Access Compliance Report

Public Rights-of-Way

(Curb Ramps)

Intersection ID: 49271	Main Street: TWIN_BROOK_DR	Cross Street: TOMSIE_EFIRD_LN	Location:	E
ADA ID: 303A3D0EE36A	Ramp Type: PerpDiag	Initial Pass/Fail: Fail	Overall Compliance: No	Severity Score: 35
Codes/Mitigation Info/Possible Solution		Field Measurements/Component Compliance

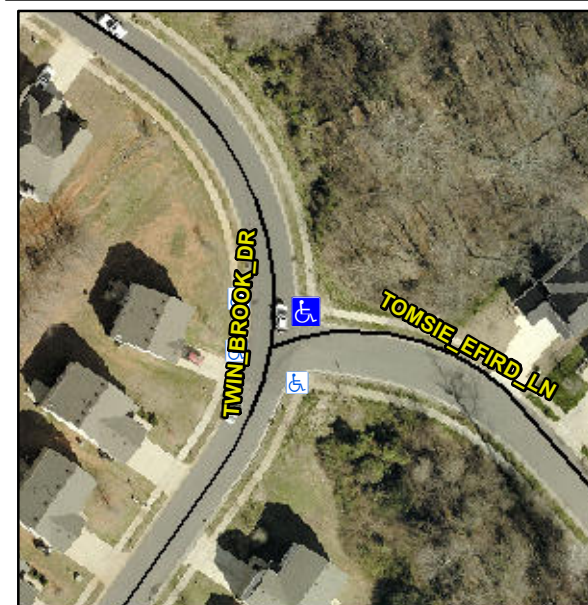
Remove & Replace Curb Ramp With Two New Directional Ramps or Equivalent.

R304.5.1, R304.2.2, R304.5.3

Compliance	Description	Data	Compliance	Description	Data
N/A	Ramp Length (in)	51.0	No	Ramp Slope (%)	16.3
No	Ramp Width (in)	45.0	No	Ramp XSlope (%)	3.2
N/A	Flare Type LT	N/A	N/A	Flare Type RT	N/A
N/A	Flare Slope LT (%)	N/A	N/A	Flare Slope RT (%)	N/A
N/A	Flare Traversable LT?	N/A	N/A	Flare Traversable RT?	N/A
N/A	Landing Length (in)	N/A	N/A	DWS Provided?	N/A
N/A	Landing Width (in)	N/A	N/A	DWS Contrast?	N/A
N/A	Landing Slope (%)	N/A	N/A	DWS Length (in)	N/A
N/A	Landing X Slope (%)	N/A	N/A	DWS Full Width?	N/A
N/A	Landing Curb? (Y/N)	N/A	N/A	DWS Offset (in)	N/A
N/A	Shared Landing?	N/A			
N/A	Gutter Ponding?	N/A	N/A	Gutter Slope (%)	N/A
N/A	Gutter Lip Ht (in)	N/A	N/A	Gutter X Slope (%)	N/A
N/A	Painted X Walk1?	No	N/A	Painted X Walk2?	No
	X Walk 1 Direction	To W		X Walk 2 Direction	To S
N/A	X Walk 1 Width (in)	N/A	N/A	X Walk 2 Width (in)	N/A
	X Walk 1 Slope (%)	8.0		X Walk 2 Slope (%)	5.9
	X Walk 1 X Slope (%)	0.9		X Walk 2 X Slope (%)	3.7
